Description	FluidX 96-format 1.0ml External Thread Jacket Tubes
Creation Date	18.05.2020
Product Change Notice Number	NOC 2008
Revision	2.0
This Product Change Notice supersedes the following documents:

1. Description and Reason for Change

Table 8.1. comparison of affected and replacement products

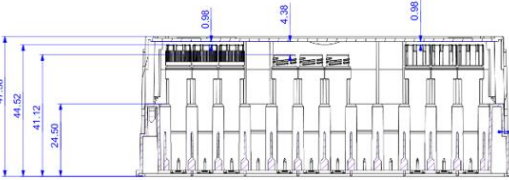
- There are some differences in tube dimensions created by this change, internal tube dimensions differ, resulting in higher working volumes. Differences are highlighted in yellow in the [table 8.1](#)

FluidX 96-format 1ml External Thread, Next Gen Jacket Tri-coded	FluidX 96-format 1.0ml External Thread, Jacket Tri-coded
Max Fill Volume 21°C (ml) screw cap	1.2	1.1
Max Working Volume - Frozen (ml) screw cap	1	0.86
Max Working Volume (µl) screw cap	999	917
Max Working Volume (µl) septum cap	916	-
Tube Height (mm)	46.2	40.3
Tube Height with Screw Cap (mm)	49.6	43.5
Tube Height with Septum Cap (mm)	47.4	42.3
Tube height in rack with Screw Cap (mm)	50.5	44.5
Overall rack height with Screw Cap & Lid (mm)	53.2	47.3
Tube height in rack with Septum Cap (mm)	47.1	-
Overall rack height with Septum Cap & Lid (mm)	53.2	-
Inner Diameter (mm)	6.5	6.5
Outer Diameter with Cap (mm)	8.7	8.8
Center to Center (mm)	9	9
Min Temperature °C screw cap	-196	-196
Min Temperature °C septum cap	-80	-80
2D Coded	Base	Base
Human Readable Number	Side	Side
Linear Barcode	Side	Side
Bulk, uncapped	68-1003-00	68-1002-00
Bulk, pre-capped	68-1003-10	68-1002-10N

Rack Comparison

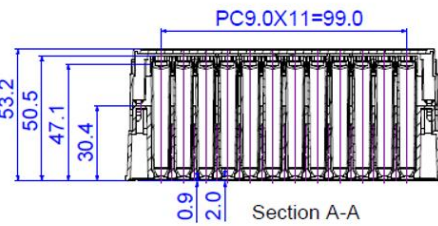
- 2D Rack ID Option Available
- External Thread Tube
- Empty Rack Part Number: 66-51019

- 2D Rack ID Option Available
- Locking Lid
- External Thread Tube
- Empty Rack Part Number: 66-51020
